Access Compliance Report

Public Rights-of-Way

Intersection ID: 18716	Main Street: COLONY_RD	Cross Street: RUNNYMEDE_LN	Location: SW
ADA ID: 8A915C3F254E	Ramp Type: PerpDiag	Initial Pass/Fail: Fail	Overall Compliance: No
Severity Score: 25			
Codes/Mitigation Info/Possible Solution		Field Measurements/Component Compliance

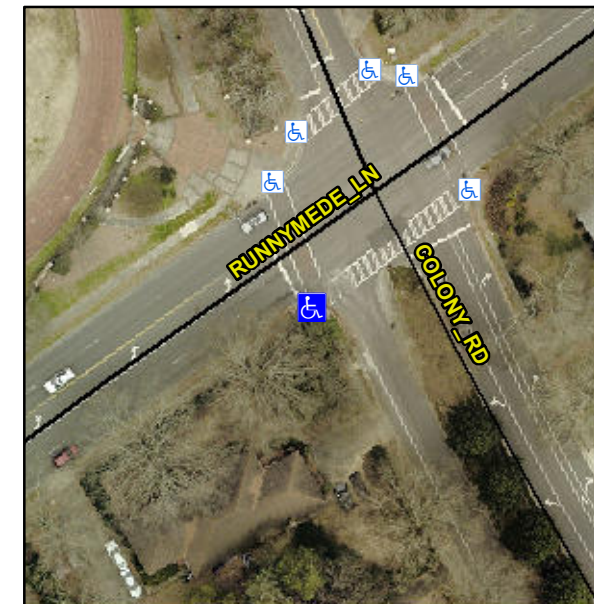
Not Found, R304.5.3

Compliance	Description	Data	Compliance	Description	Data
N/A	Ramp Length (in)	72.0	Yes	Ramp Slope (%)	5.6
Yes	Ramp Width (in)	48.0	No	Ramp XSlope (%)	8.3
N/A	Flare Type LT	N/A	N/A	Flare Type RT	N/A
N/A	Flare Slope LT (%)	N/A	N/A	Flare Slope RT (%)	N/A
N/A	Flare Traversable LT?	N/A	N/A	Flare Traversable RT?	N/A
N/A	Landing Length (in)	N/A	N/A	DWS Provided?	N/A
N/A	Landing Width (in)	N/A	N/A	DWS Contrast?	N/A
N/A	Landing Slope (%)	N/A	N/A	DWS Length (in)	N/A
N/A	Landing X Slope (%)	N/A	N/A	DWS Full Width?	N/A
N/A	Landing Curb? (Y/N)	N/A	N/A	DWS Offset (in)	N/A
N/A	Shared Landing?	N/A			
N/A	Gutter Ponding?	N/A	N/A	Gutter Slope (%)	N/A
N/A	Gutter Lip Ht (in)	N/A	N/A	Gutter X Slope (%)	N/A
N/A	Painted X Walk1?	Yes	N/A	Painted X Walk2?	Yes
	X Walk 1 Direction	To NE		X Walk 2 Direction	To NW
N/A	X Walk 1 Width (in)	117.0	N/A	X Walk 2 Width (in)	118.0
	X Walk 1 Slope (%)	1.9		X Walk 2 Slope (%)	2.0
	X Walk 1 X Slope (%)	2.0		X Walk 2 X Slope (%)	0.5

Remove & Replace Curb Ramp With Two New Directional Ramps or Equivalent.
